BEFORE THE NEW MEXICO PUBLIC REGULATION COMMISSION

CASE 13-00390-UT

**Direct Testimony and Exhibit in Opposition to PNM's Original and
Supplemental Stipulation Agreements**

**On Behalf of
New Energy Economy**

1 **Figure 1. San Juan variable costs (orange) as compared to other PNM units (gray) (a) as modeled**
 2 **and (b) adjusted to incorporate all coal contract costs as variable after expiration of contract in 2022**

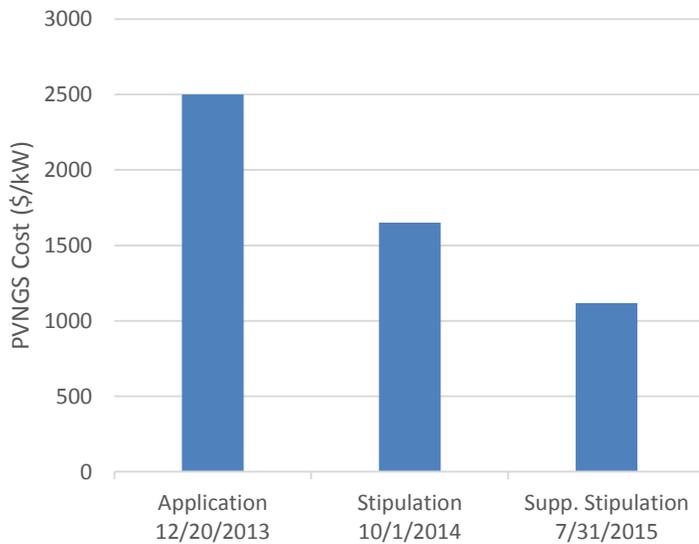
10 The relative impacts of modeling the contract in this way are clear. When choosing which
11 plants to dispatch in any given hour, the Strategist model dispatches plants based on
12 lowest marginal cost. No variable O&M costs are modeled at SJGS, and only the very
13 low “Tier 2” fuel costs are included on an operational timeframe. As a result of these
14 unrealistically low hourly operational costs of the plant, the SJGS is utilized more than it
15 otherwise would be. This makes the Strategist model runs that include additional capacity
16 at SJGS appear more cost effective than they otherwise would.

13 **A** As modeled by the Company, SJGS has no variable operational costs beyond the
14 “incremental” coal contract costs, which represent up to a third of the total per mmbtu
15 coal costs in each year. Strategist lacks the capability to endogenously retire SJGS if
16 overall costs are uneconomic. In other words, the model cannot choose to retire SJGS
17 within the course of its optimization –retirements are analyzed by conducting a series of
18 model runs with retirement dates “hard coded” into the model by analysts. As a result,
19 when the model sees an artificially low operational cost it dispatches the plant at a high

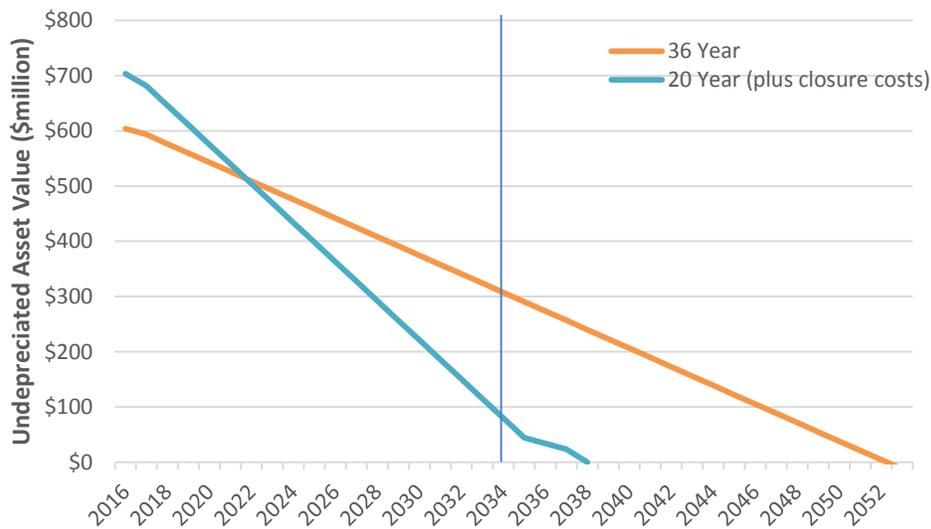
3 **A** Yes. I will explain the \$130 million cost associated with the *4 Unit Shutdown* scenario
4 first. This cost includes both incremental closure costs and the impacts of an accelerated
5 depreciation schedule, from 36 years to 20 years. I will then explain the \$56 million
6 savings associated with the Stipulation portfolio analysis. This analysis calculates the
7 incremental costs associated with an accelerated depreciation from 36 years to 20 years,
8 and assumes a 50 percent reduction due to Stipulation terms. Together, the San Juan
9 Investment Recovery adjustments lead to a post-hoc delta between the Stipulation and *4*
10 *Unit Shutdown* portfolios of \$186 million.
